Rev. 3

EM-225A

POST ACCIDENT RB HYDROGEN CONTROL

# PROCEDURE DEVELOPMENT AND REVISION RECORD

ACCESS ROUTES

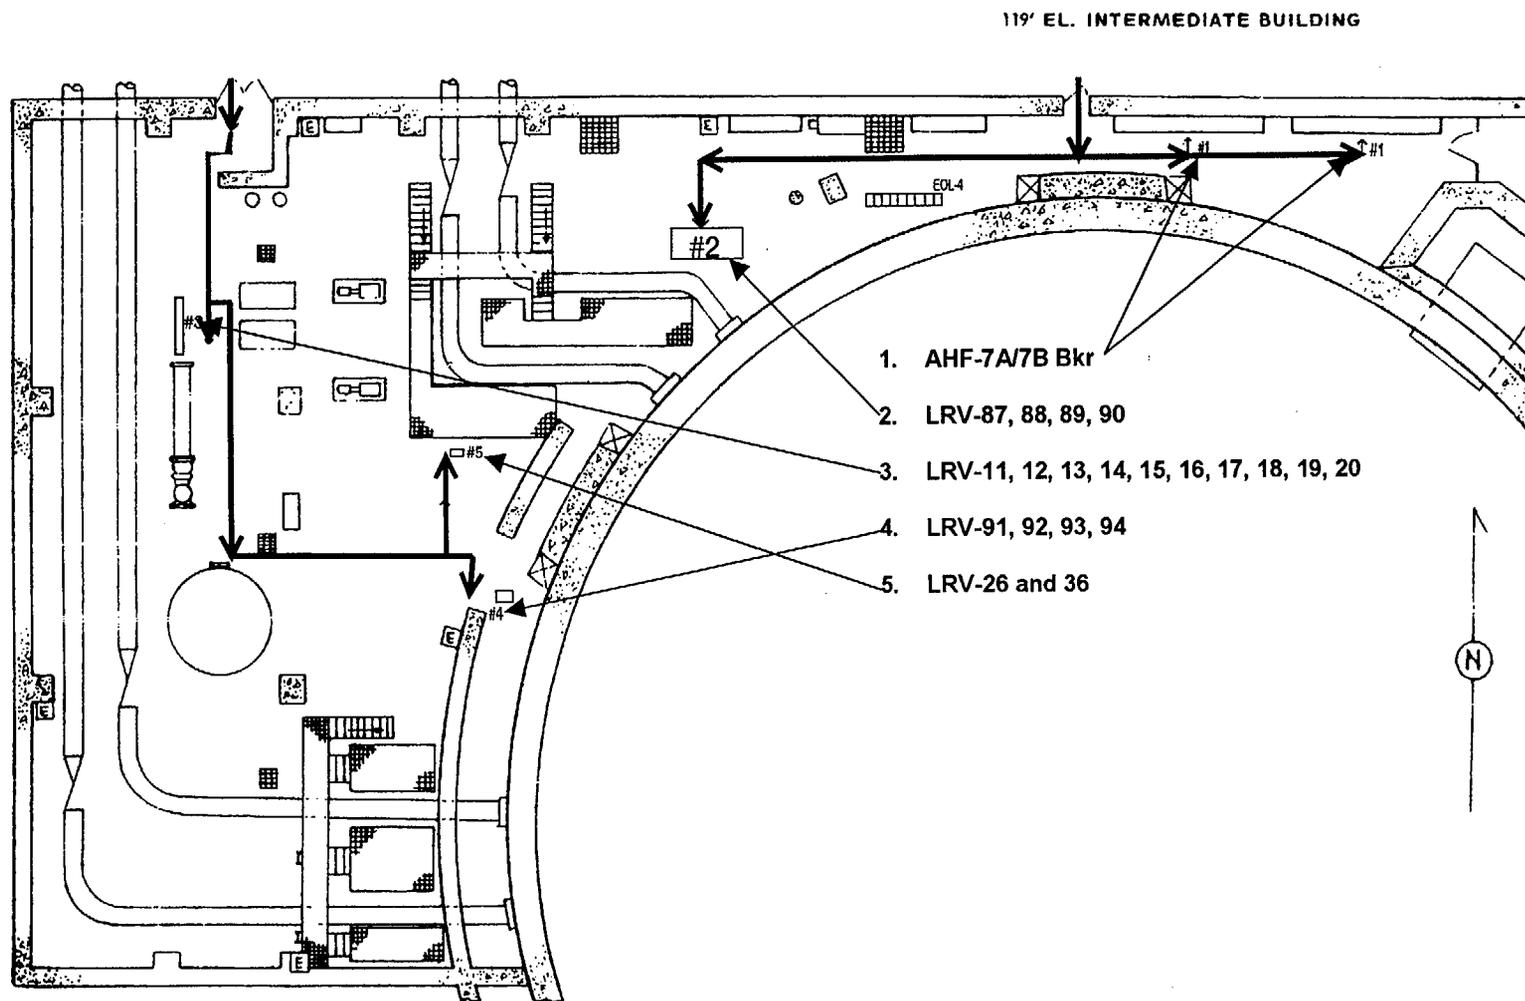
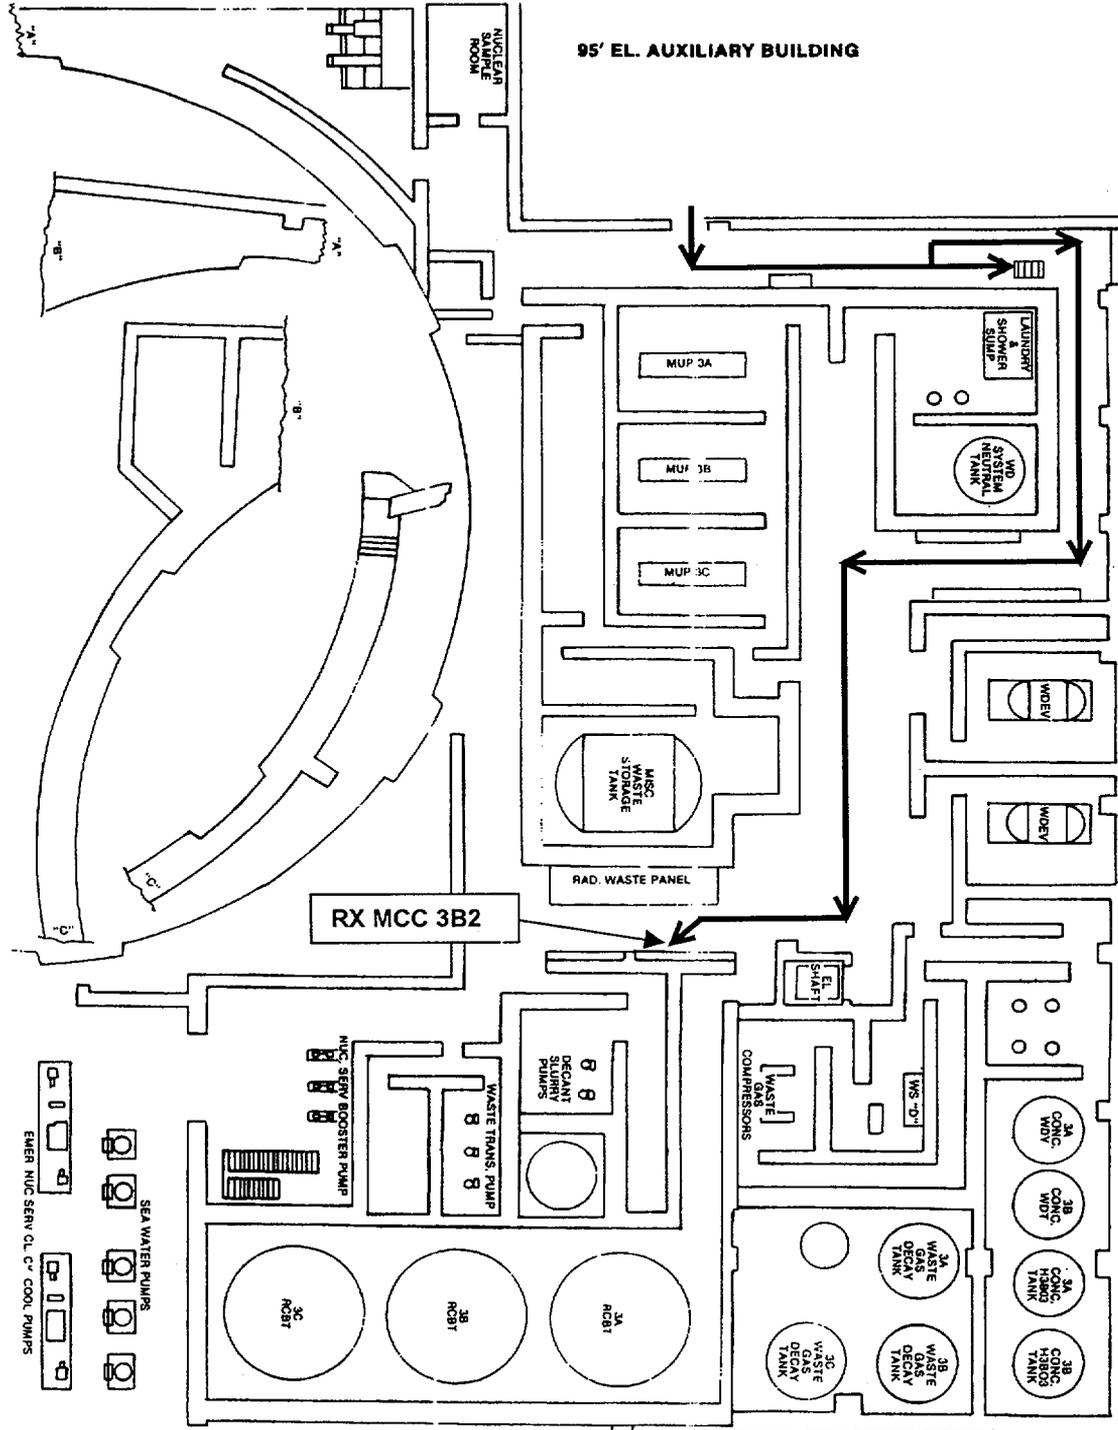
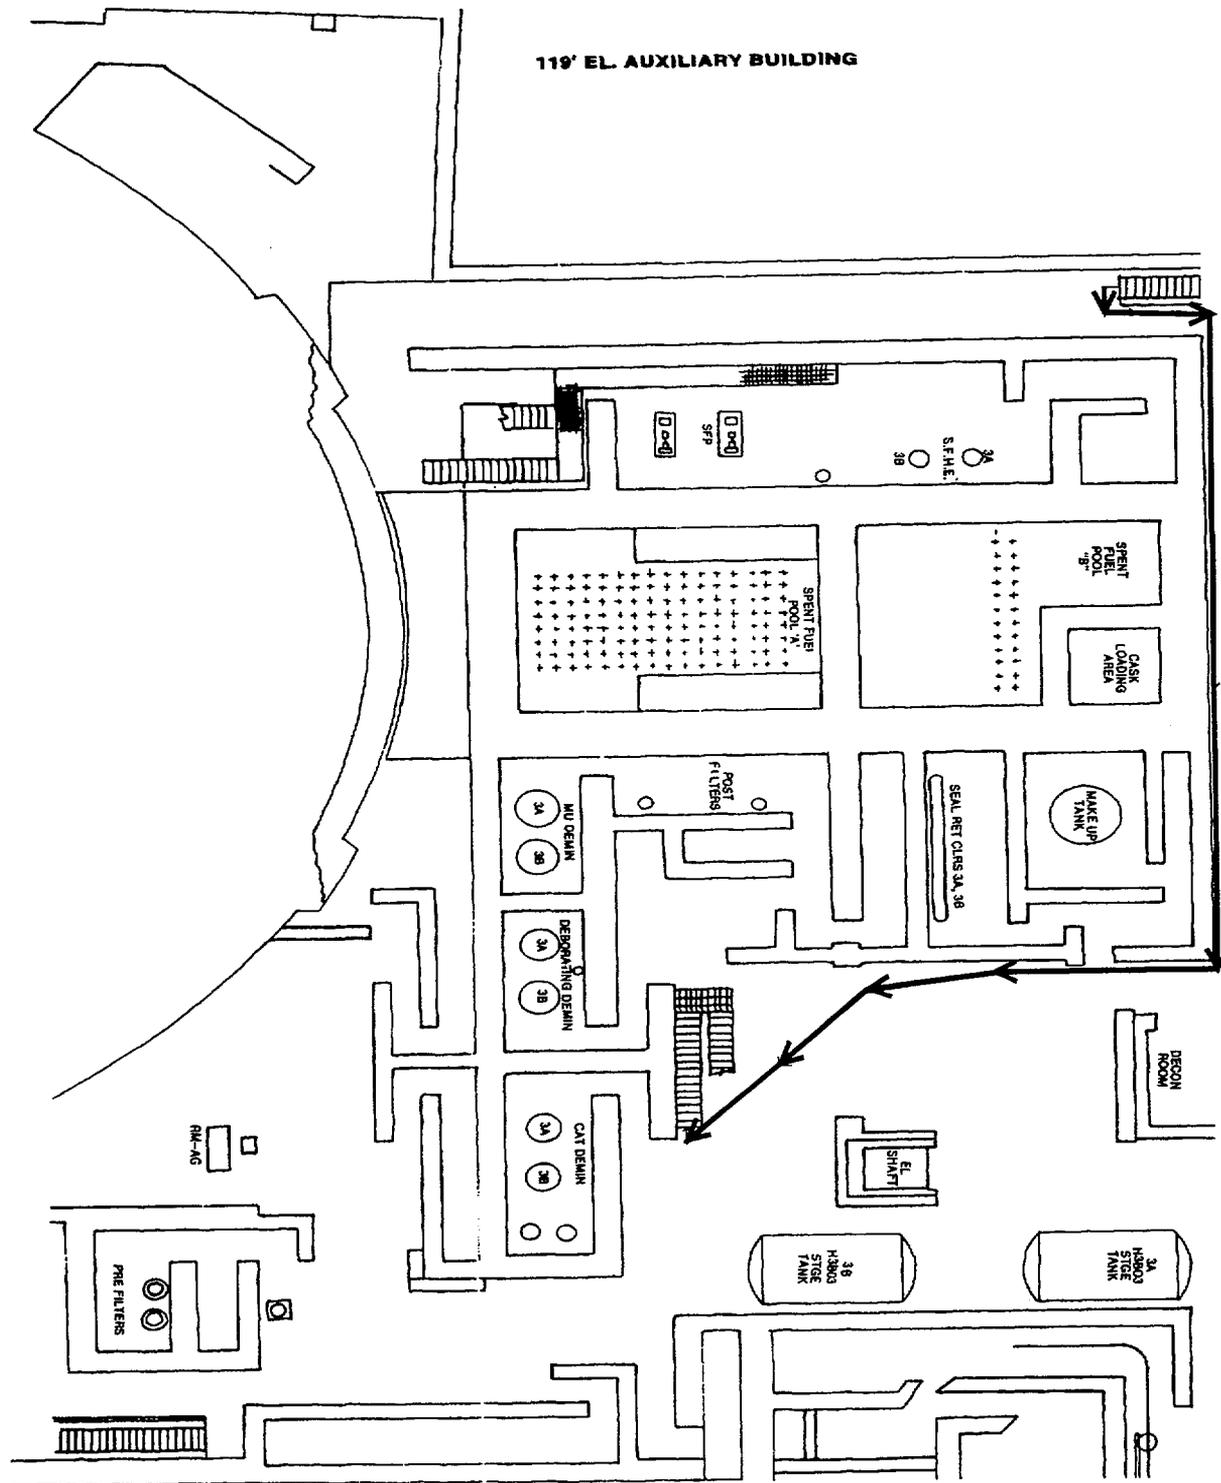
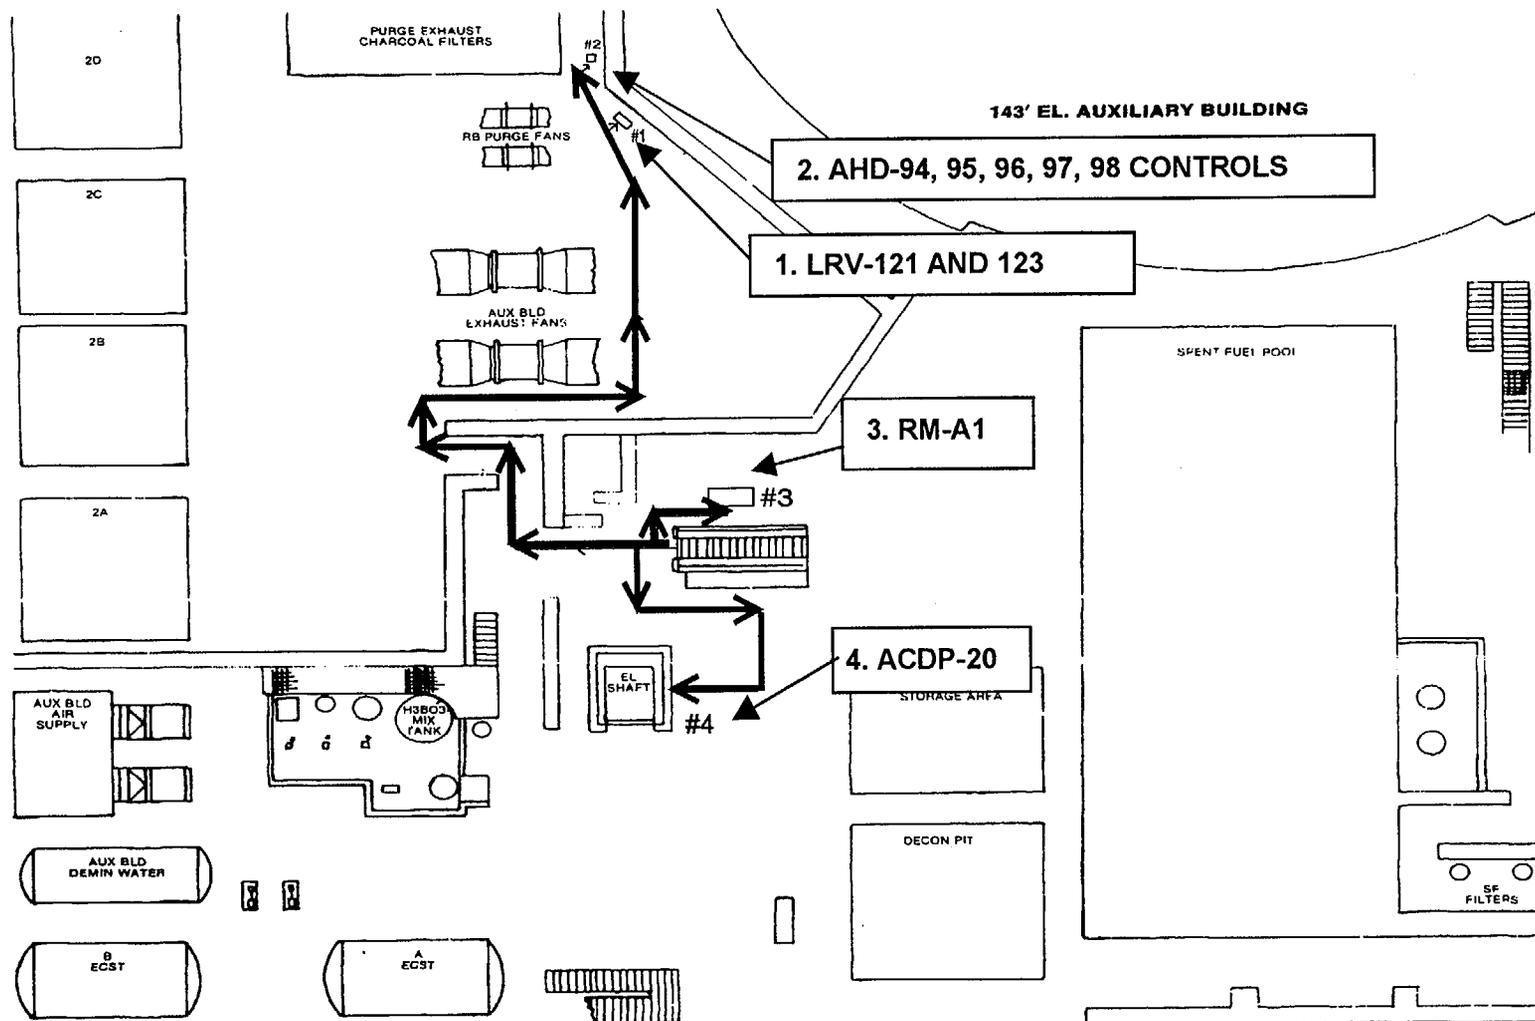
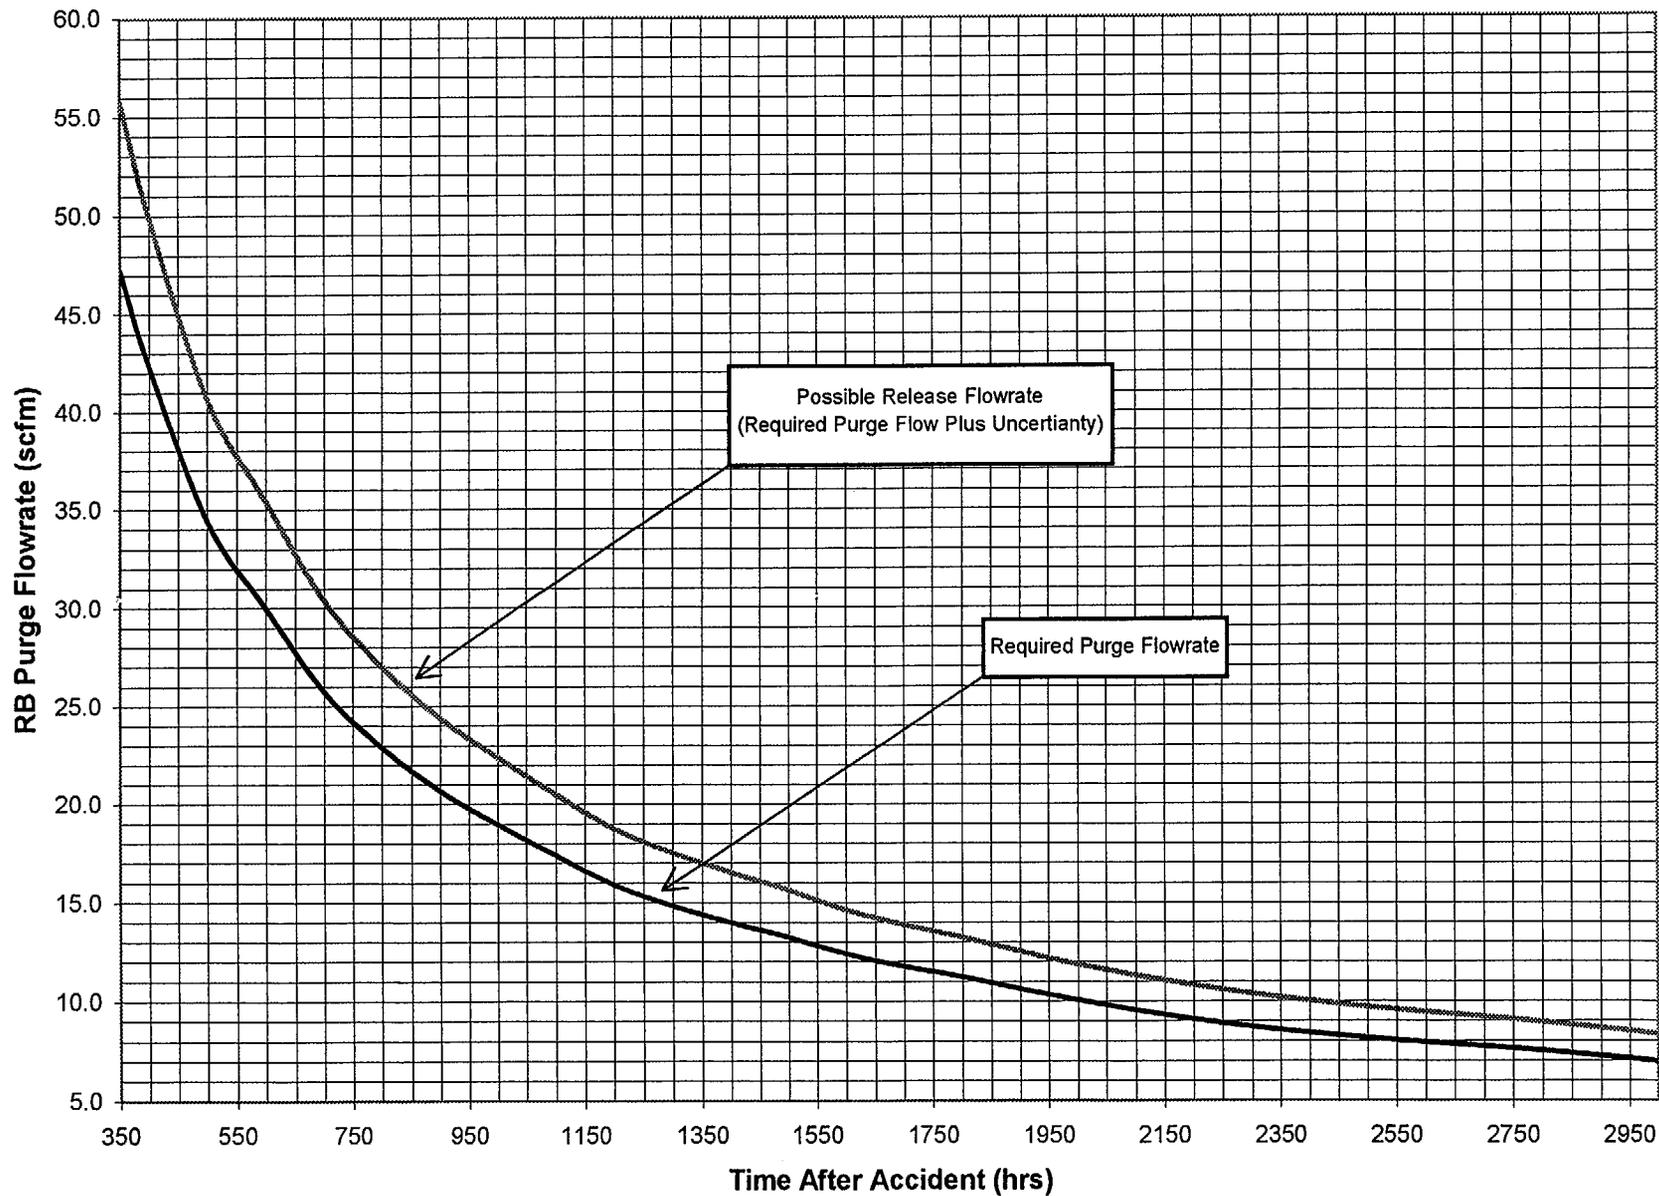
**Enhanced the locations of the equipment and access routes to make it less confusing and more pronounced.**

HYDROGEN PURGE SYSTEM FLOW DIAGRAM

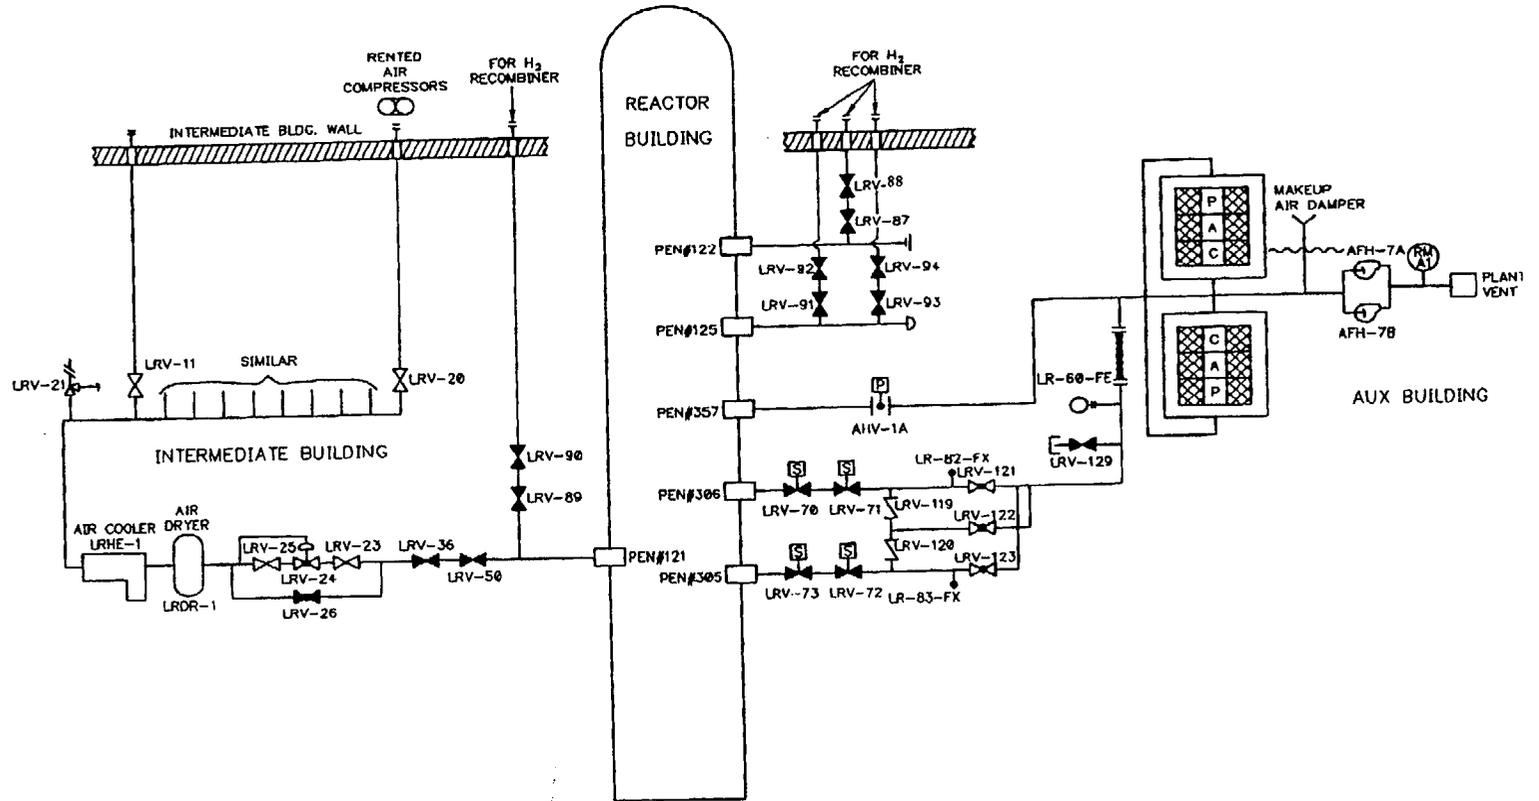
**Added Enclosure 11 to give a system flow diagram of the Hydrogen Purge System. This gives a pictorial view of the valve arrangement to allow a good understanding of the procedure.**
